PLANNING COMMISSION

SITE AND DESIGN REVIEW STAFF REPORT

FILE #: DR 14-01

Prepared for the April 14, 2014 Planning Commission Meeting

DATE: NOVEMBER 2013
SCALE: PROJECT NO. 20130884
DRAWN: CHECKED:
SHEET NO. **G7.0**

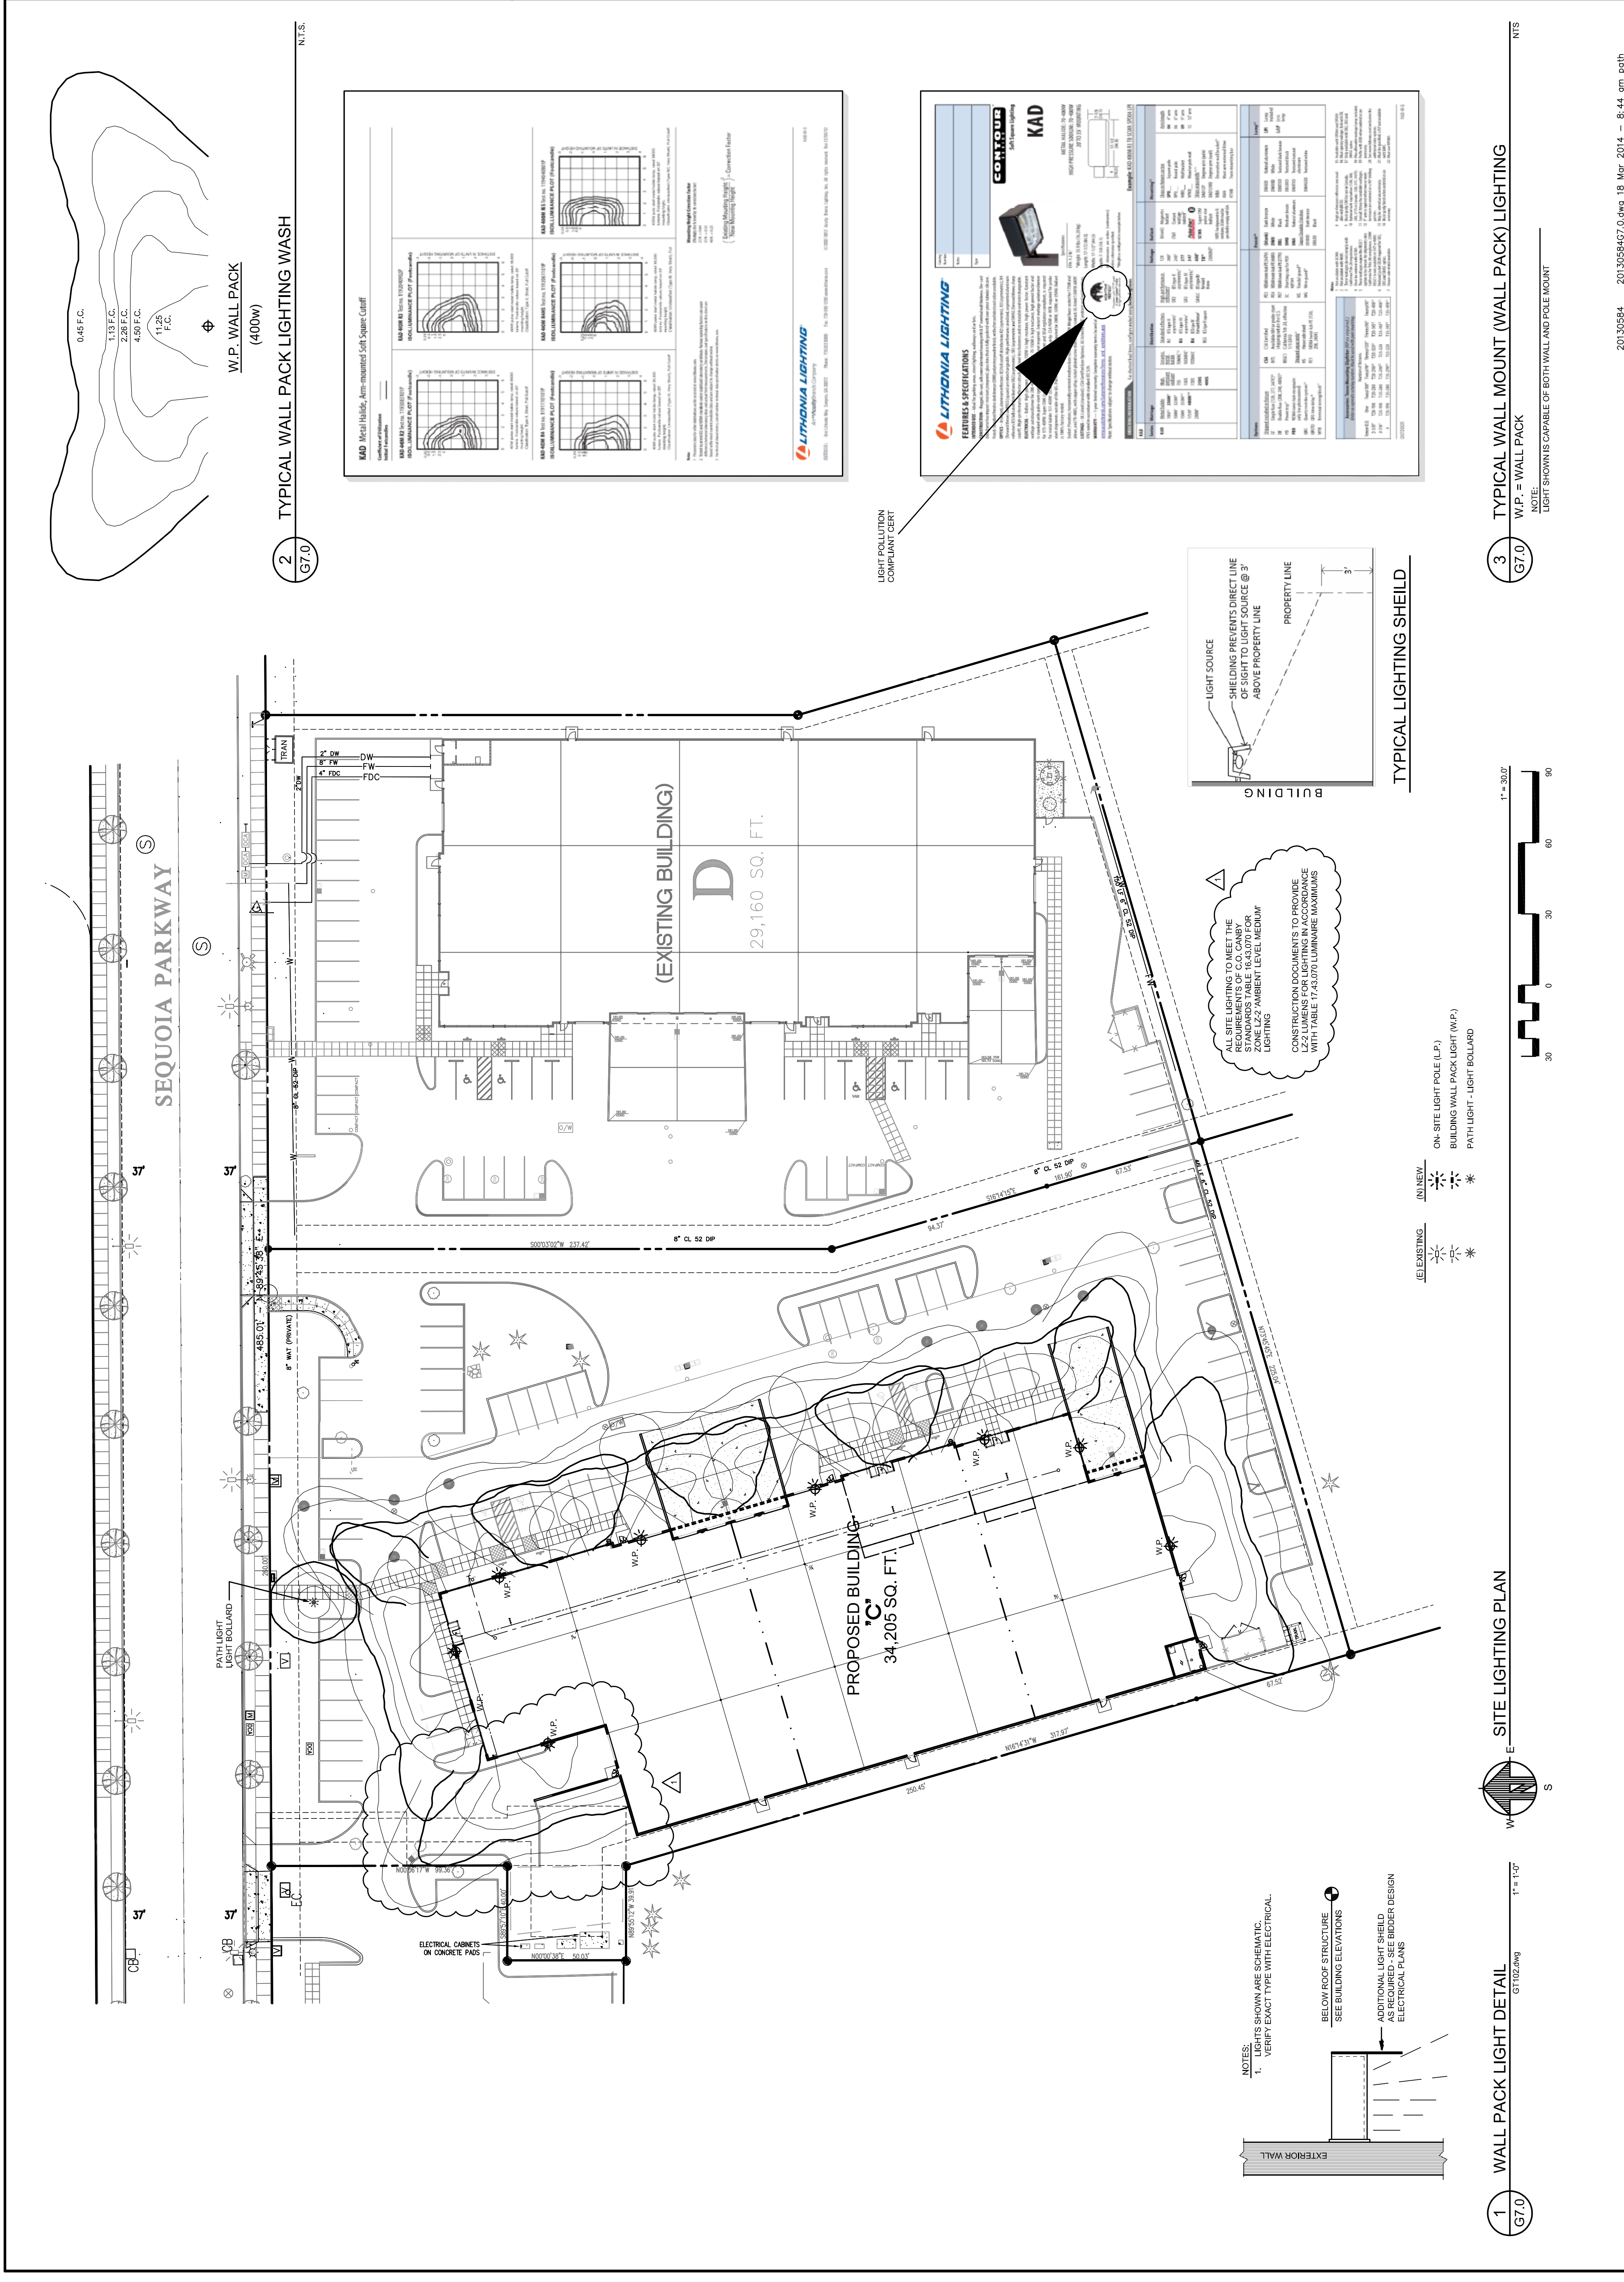
Findings: The submitted lighting plan does not show lumen values and shielding to demonstrate compliance with Table 16.43.070. Staff would like feedback on what type of category lights should be required and what lumen limits should be required; **Condition #7** should be worded accordingly. Industrial zones are part of the “LZ 2” zone.

TREND BUSINESS CENTER
 341 SEQUOIA PARKWAY
 CANBY, OREGON
LANDSCAPE PLAN
 DATE: NOVEMBER 2013
 SCALE: PROJECT NO. 20130584
 NOTED: DRAWN: CHECKED: AUC
 SHEET NO. L1.0
 1 OF 1

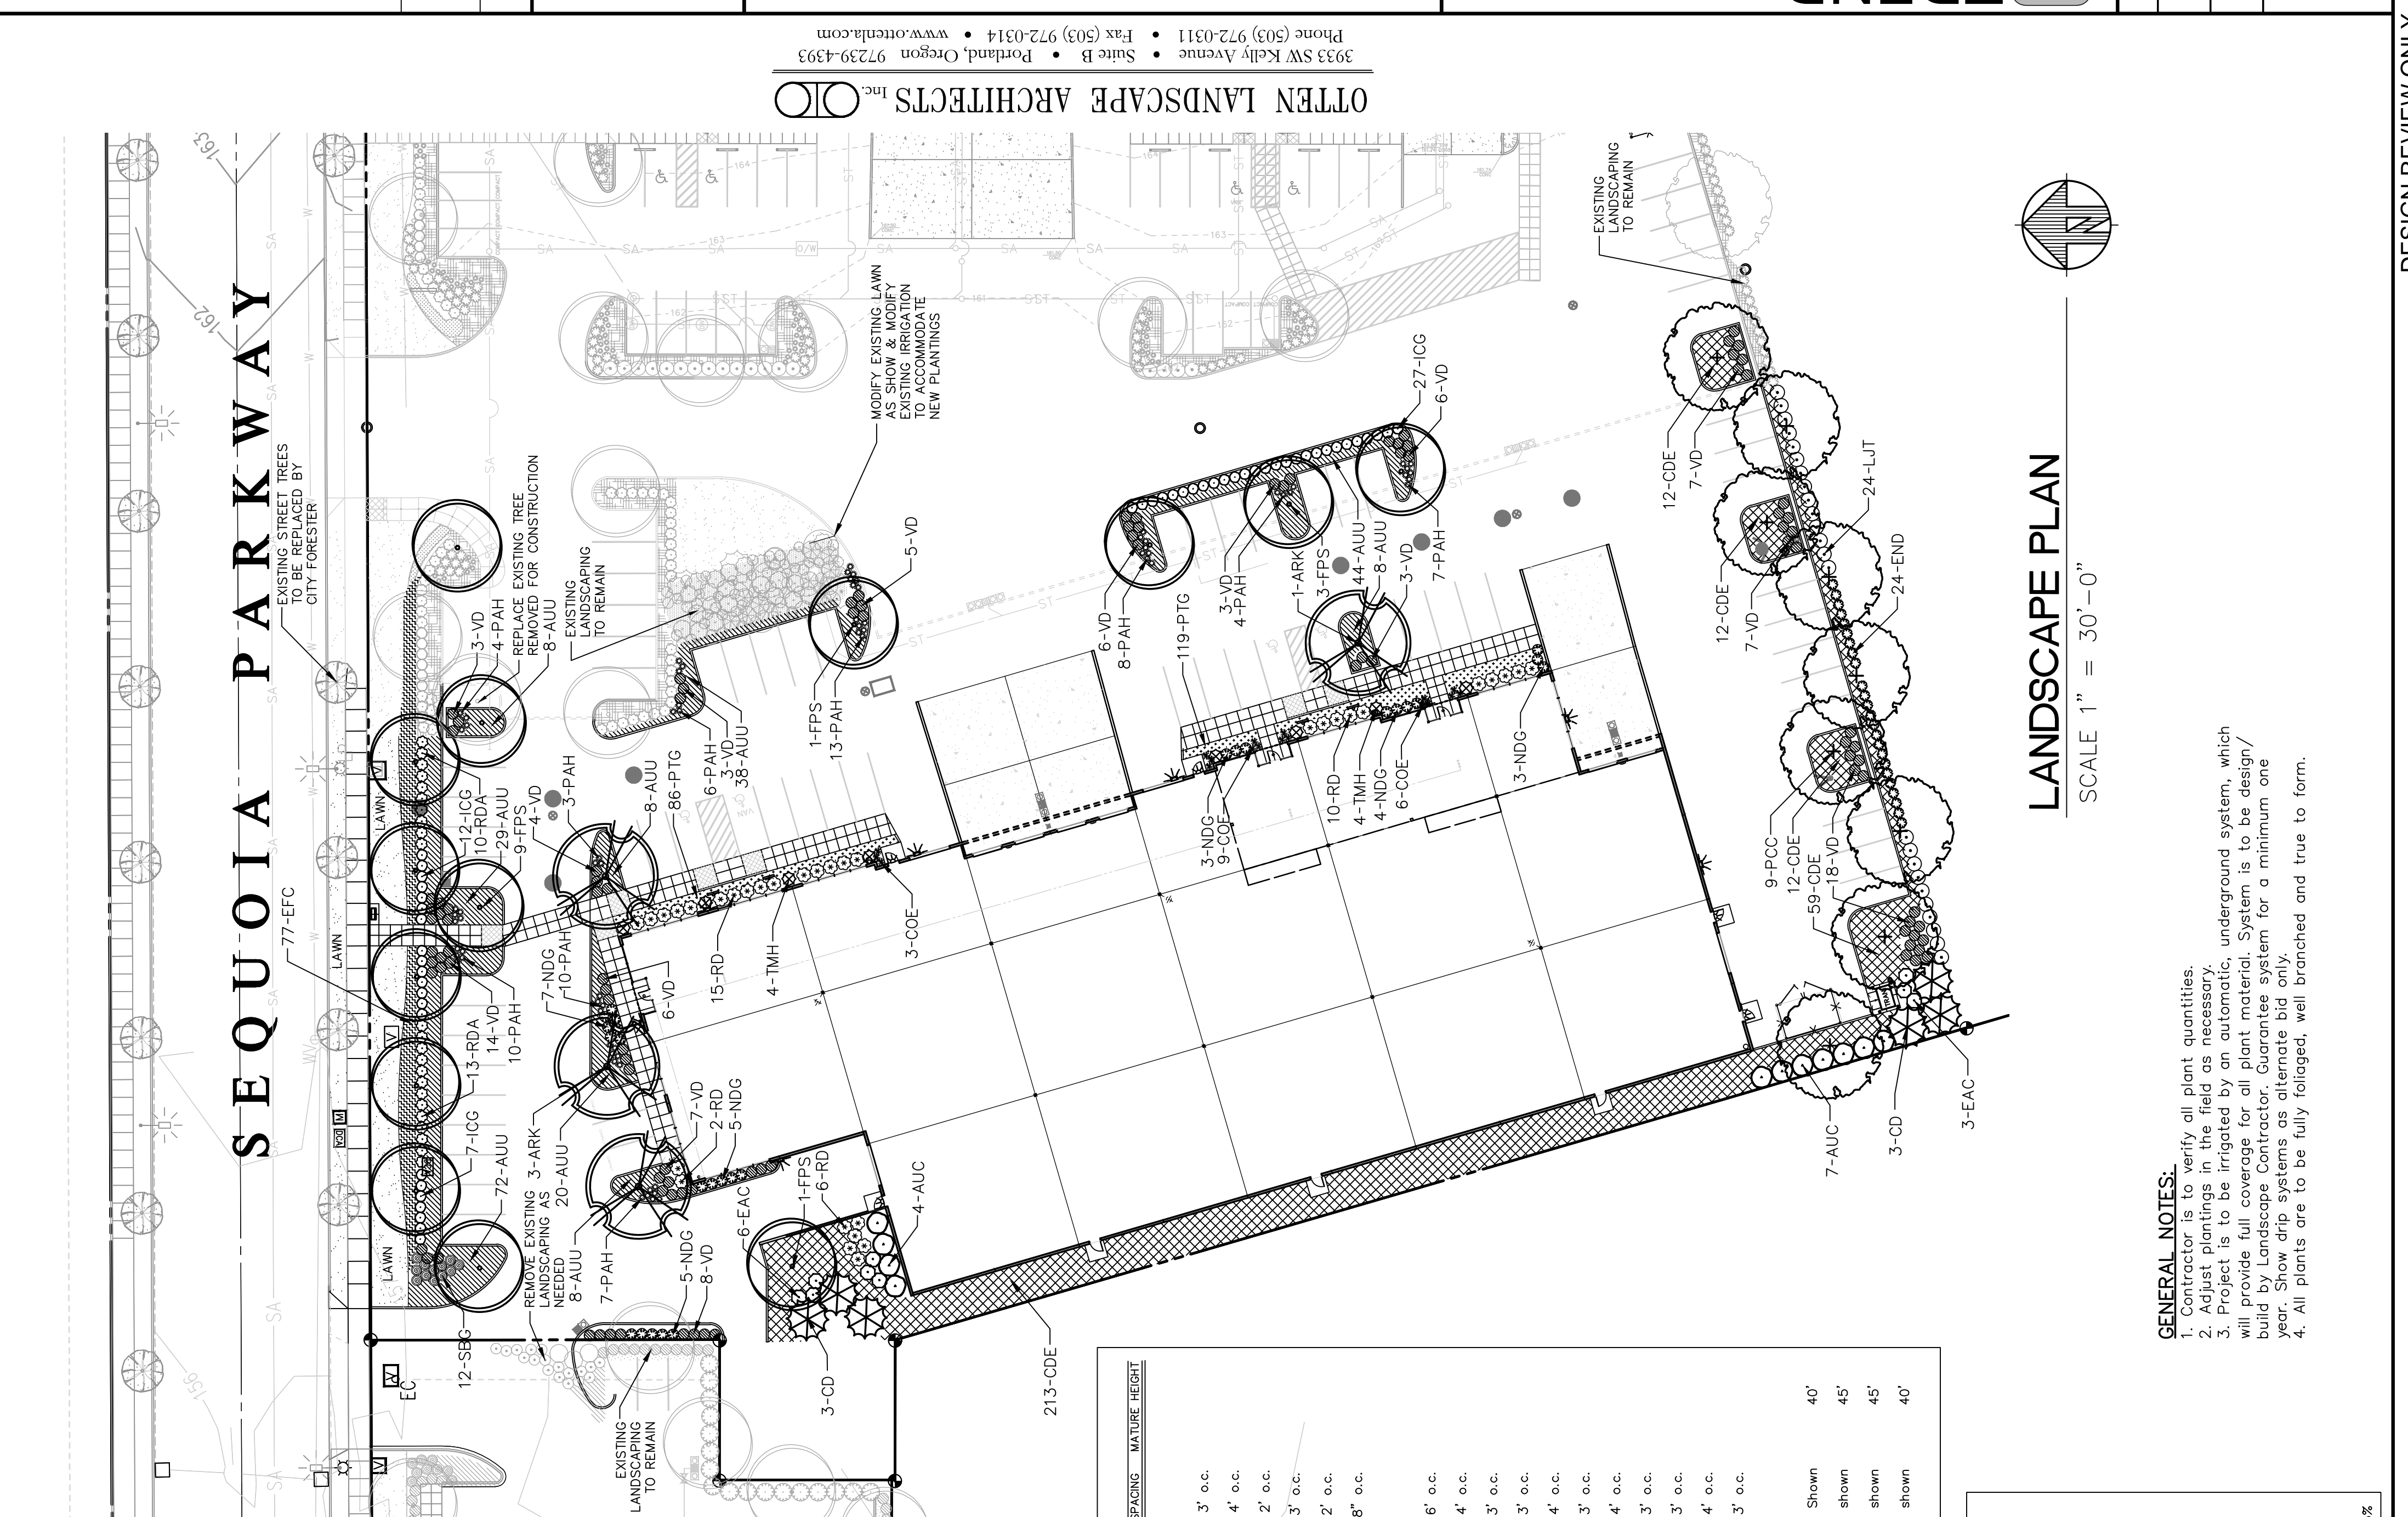
- A bench is being provided at the public sidewalk/on site walkway connection, therefore 1 point is assigned.
- The applicant’s landscaping plan shows 100% landscape coverage. However, plants will be mulched and 100% coverage at plant maturity is unrealistic. Staff has noted this section as a potential code edit and 2 points have been assigned.

Section I specifies that the landscaping shall be covered by grass or ground covering within 3 years of installation and permits up to 5% of the landscaped area to be covered with mulch. The applicant’s landscaping plan shows 100% landscape coverage. However, plants will be mulched and 100% coverage at plant maturity is unrealistic. Staff has noted this section as a potential code edit.
